**Embassy Parking Garage Renovations, 2024**

**ADDENDUM NO. 5**

April 10, 2024

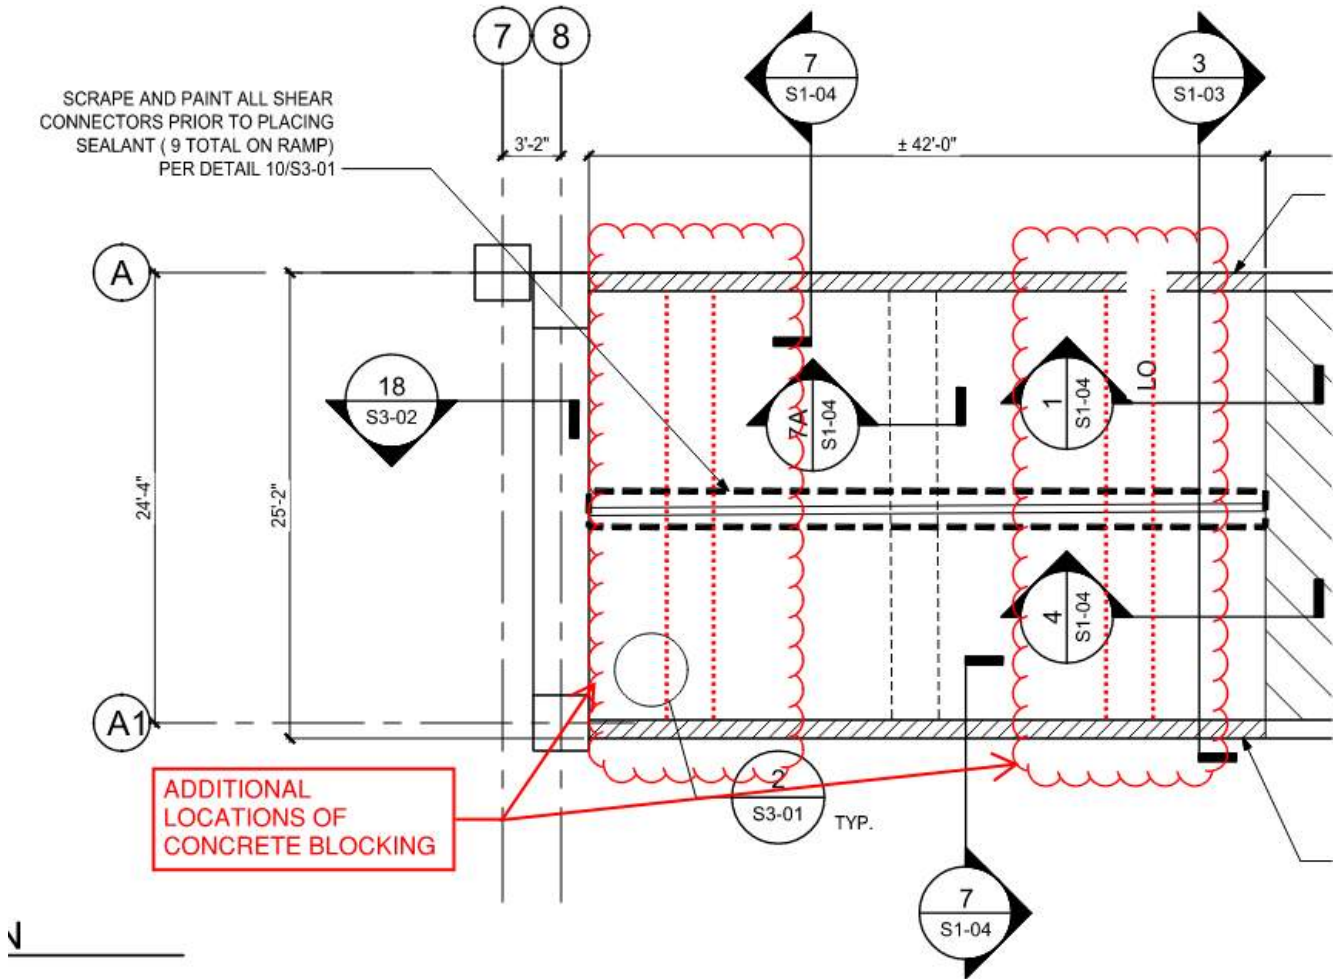
**Q2.** Please provide following details for Concrete Spandrel Wall:

- a. As Built/Shop Drawings of existing concrete spandrel wall at ramp.
- b. Existing connection detail of precast ramp tees to Spandrel Wall and spacing of connection.
- c. Existing Connection Detail of concrete spandrel wall at ends on ramps on underside.
- d. As per detail 7/S1-04 – Concrete Ramp Spandrel – Please provide details of tee to wall connection which is missing as per picture below? Please confirm if contractor to provide new connection with assembly or can reuse existing one?

**A2.a** – There are no existing As-Built or shop drawings for the concrete ramp spandrel.

**A2.b** – The connection of the precast ramp tee to the existing concrete spandrel wall is a welded bar between two embedded plates, similar to details 10/S3-01 and 11/S3-01. This

connection occurs at approximately 4'-0" on center. See attached photos for more information.

A2.c – One end of the existing ramp spandrel wall is bearing on the vertical concrete ramp wall. The top end of the ramp is bearing on a concrete L-Beam. See 2/S1-03.

A2.d – The connection of the Concrete Spandrel Wall to the tee will be achieved via the reinforcing bars from the Concrete Blocking per detail 7A/S1-04. This will occur at 1/4 points on the ramp (See 1/S1-03 Plan Below).

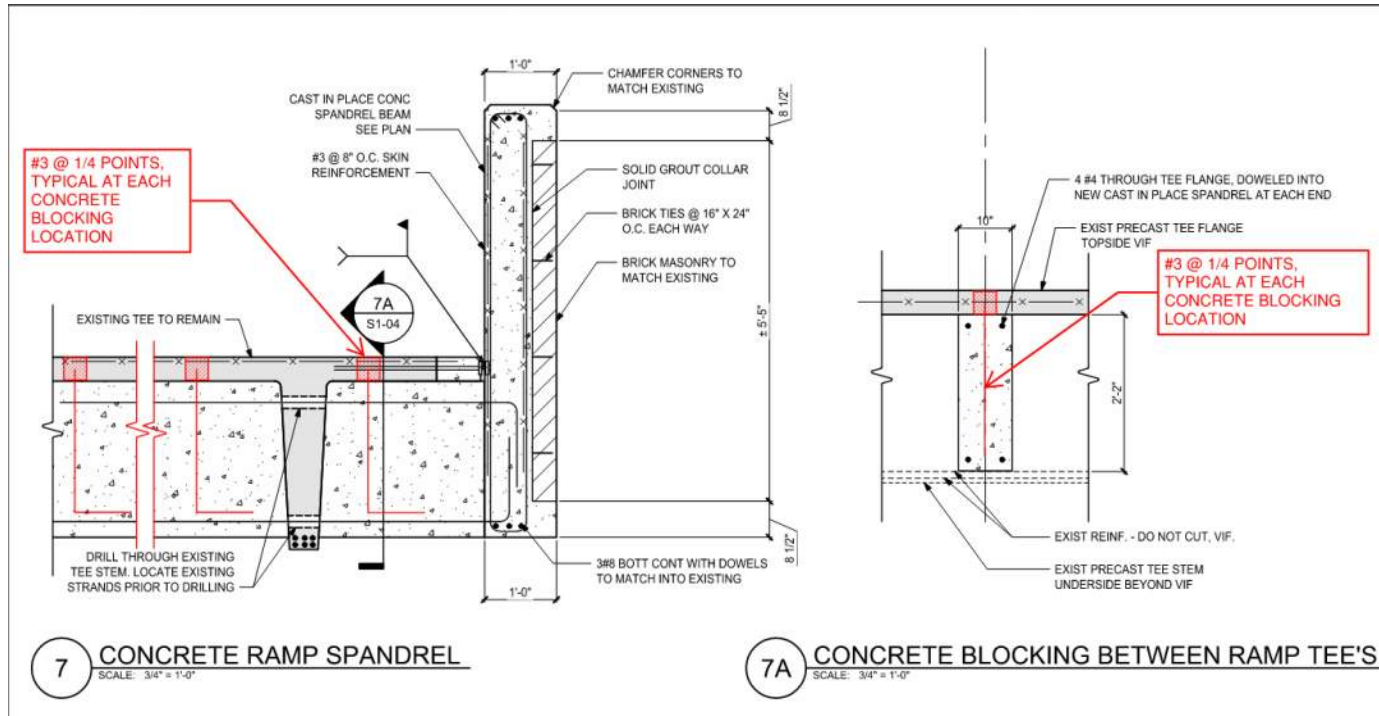
**Q3.** As per detail 7A/S1-04 – Concrete Blocking Between Ramp Tee’s – please confirm there is no doweling needed at underside of existing precast tee flange while building up the new concrete blocking between ramp tee’s.

**A3.** See revised detail 7/S1-04 & 7A/S1-04 below.
